ALTITUDE ASPIRE REVISED TRANSPORT ASSESSMENT FOR PREFERRED PROJECT REPORT (PPR)

FOR
NEWLAND

Table 7.1 provides a response to relevant submissions received for “ALTITUDE ASPIRE – MP09_0166” and details how the revised development addresses each item raised in regards to transport.

Figure 5.1: Site Access Intersection with Fraser Drive

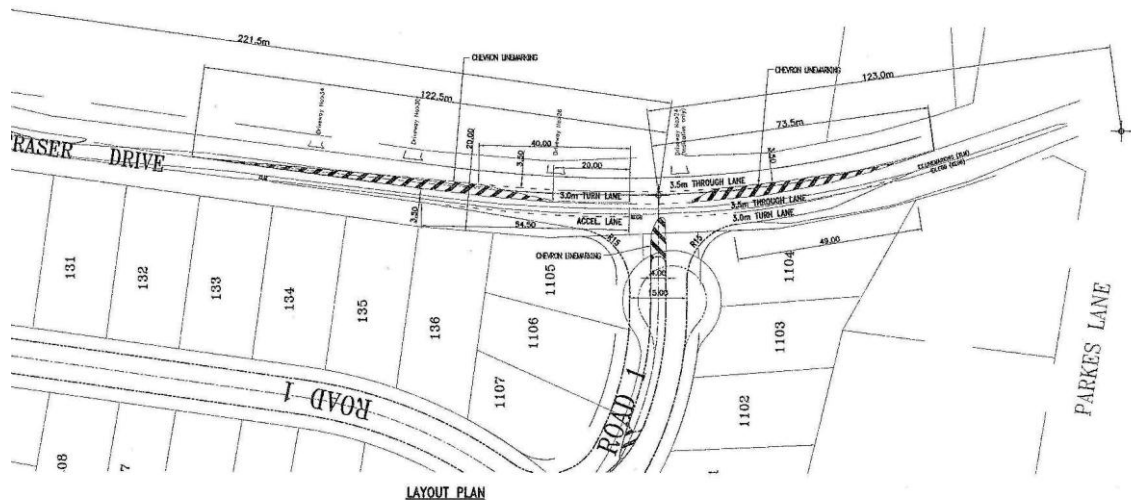
No.	Name/ Organisation	Submission	Bitzios Response
1.1	Tweed Shire Council	Traffic The report discusses the proposed "temporary access" from the subdivision to Fraser Drive, near the south eastern corner of the development. The report states that construction of Broadwater Parkway is to occur concurrently with Stage 7 of the development, subject to acquisition of the road corridor for the Parkway. Once connected to Broadwater Parkway, the "temporary access", which would be provided as an easement over a residue parcel, would be closed and redeveloped into residential allotments. As discussed previously with DoP, Broadwater Parkway is included in the Tweed Road Contribution Plan (TRCP) works program, and is subject to a Local Area Contribution. As a result, the construction is dependent on the development of Area E alone, not the broader Terranora / Banora Point area. As such, limited investigation of the road alignment and its potential environmental impacts has occurred, and no efforts have been made at present to acquire a future road alignment or to gain approval to construct the road. The draft preliminary road alignment that is referenced in the EA from Tweed Shire Council is not a final or endorsed route. As is discussed elsewhere in this report, further analysis has been undertaken, identifying an alternate alignment, displayed in Figure 6. The Broadwater Parkway is a long term prospect linked to other potential development projects in Area E, and cannot be relied upon by the subdivision for road access. As such, the subdivision must demonstrate that it has an acceptable alternate road access, to be considered a stand-alone development.	It is agreed that construction timing of Broadwater Parkway is not defined and dependant on development of the greater Area E, not particular stages of this development. The temporary access intersection with Fraser Drive has been assessed to cater for full development of Altitude Aspire. In the event that Broadwater Parkway is not opened and this stage. The assessment confirms that the temporary intersection will continue to operate at acceptable capacity limits. Therefore, the proposed development is not restricted to particular staging prior to the construction of Broadwater Parkway and can function accordingly without Broadwater Parkway without adversely impacting the surrounding road network.

Figure 6.2: Potential Bus Routes

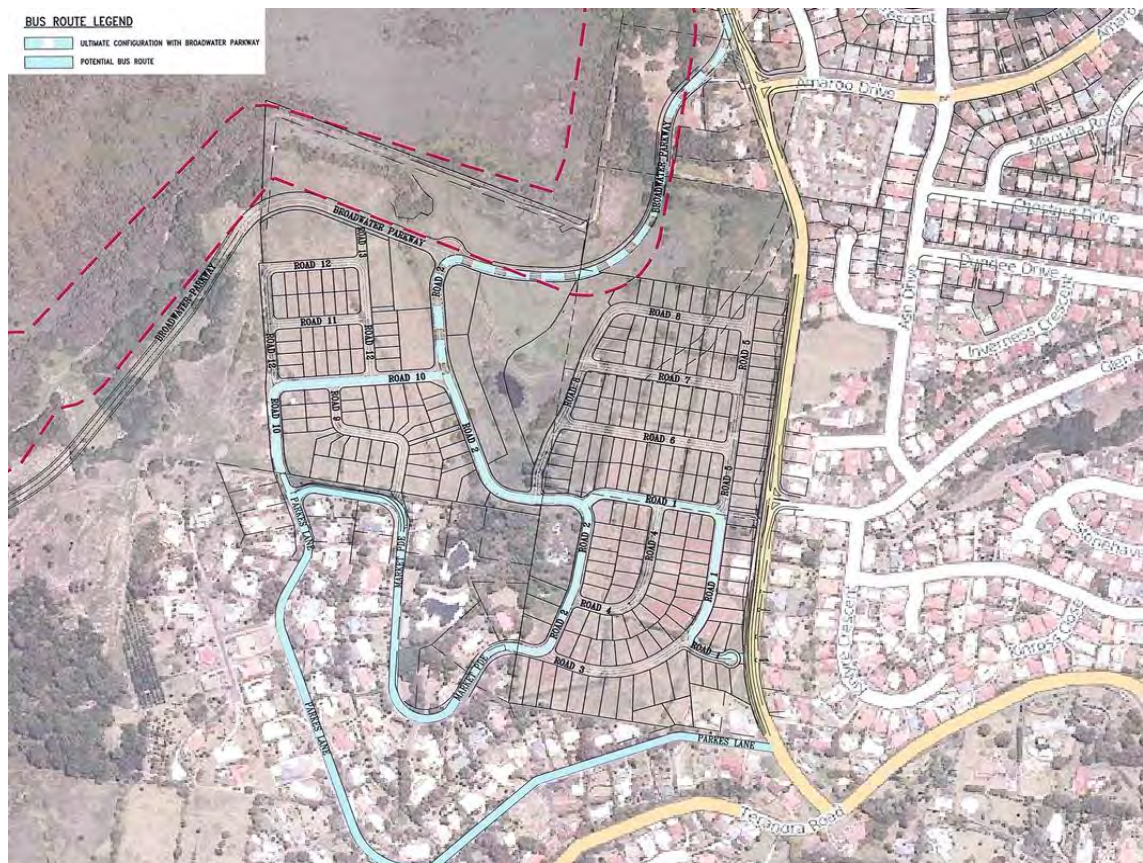
No.	Name/ Organisation	Submission	Bitzios Response
1.3		Attachment 1) or a roundabout is to be constructed at the intersection of the connection road from Fraser Drive and the main internal road in Stage 4. Bus routes are depicted in Figure 6.2 of the report based on the Broadwater Parkway being constructed. The report should also consider an alternative bus route based on the Broadwater Parkway not being constructed. This will affect carriageway widths which are to be designed to cater for any anticipated bus route (i.e. 9 m minimum carriageway widths). These routes should be provided for further assessment or alternatively a condition of consent should be included in any approval requiring the identification of potential bus routes without the proposed Broadwater Parkway being constructed.	Guidelines as detailed in the site plans. The potential public transport routes through the site have been discussed and approved with Transit Australia Group (TAG) responsible for Surfside bus lines routes and public bus services. Liaison with TAG in regards to the potential bus routes (both public and school routes) through the site without the inclusion of Broadwater Parkway has confirmed that bus routes would be based on potential catchment requirements within Altitude Aspire and be primarily based on extension of existing routes where and if required.
